Memorandum

To	Blair Devlin
Copy	Tony Gordon, Richard Hilliard
From	Amy Prestidge
Office	Christchurch Environmental Office
Date	22 March 2019
File	6-XQ074.04/005
Subject	Flint's Park 3 Waters Summary Review of EOI and Addendum

This modified memorandum was prepared following receipt of the Addendum to Flint's Park SHA document that had not been received at the time of writing the original memorandum. The body of the memorandum remains unchanged; additional comments have been made at the end of the original content.

Figure 3 – Flint's Park Mixed Use Precinct (with Flint's Park SHA and Glenpanel SHA also shown)

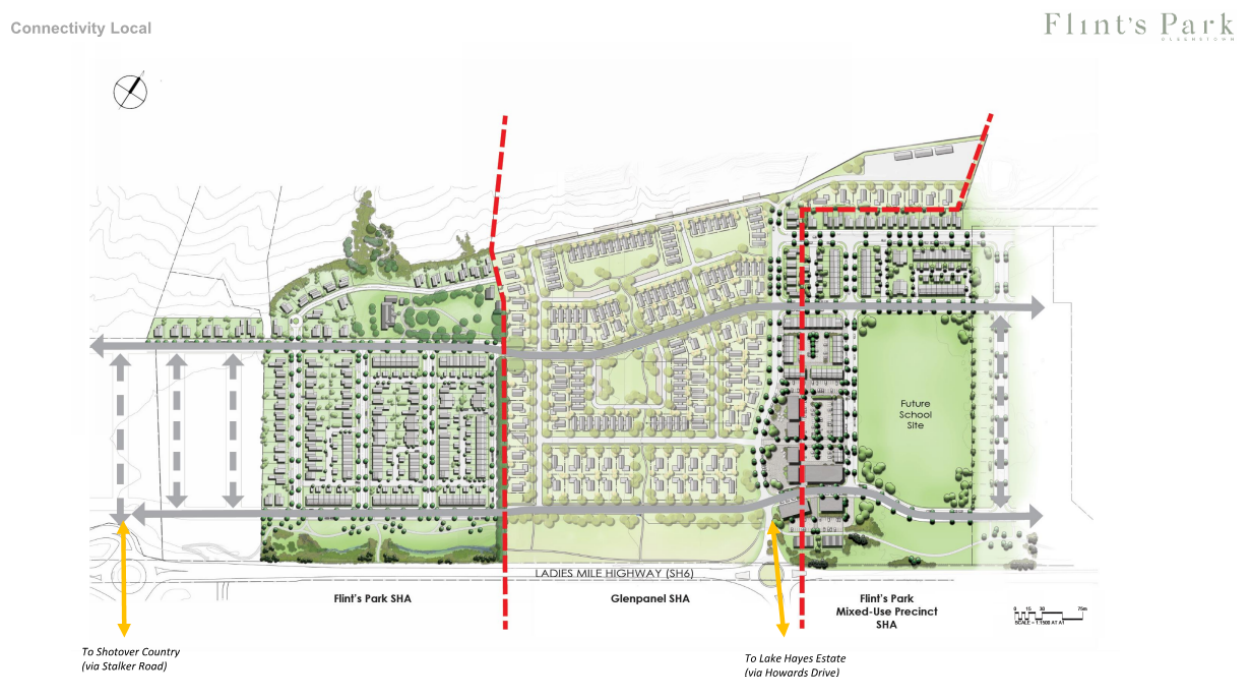
The Addendum to Flint's Park SHA EOI document along with its appendices were received on 21 March 2019. The Addendum covers a new area to the east of the proposed Glenpanel development, referred to as the Flint's Park Mixed-Use Precinct, resulting in the Flint's Park development flanking the Glenpanel development on each side (refer Figure 3)

- It is acknowledged that this area is outside that originally included in the stormwater area assumed for the design of the Howards Drive stormwater pipe. The proposal to attenuate both areas to reduce outflows to match that of the Flint's Park SHA area, and so match the assumed contributing area for the Howards Drive stormwater pipe, is acceptable.
- Where the boundary is between the Flint's Park Mixed Use Precinct and the Glenpanel SHA is unclear. The roadway appears in both proposals. The rising and falling mains to and from the proposed QLDC Ladies Mile reservoir may follow the road. It is important that this is not missed by whoever carries out the designs for the proposals.
- Whilst there are unlikely to be any water supply issues, water supply design needs to take into account the changes that have occurred since the HIF report was prepared.
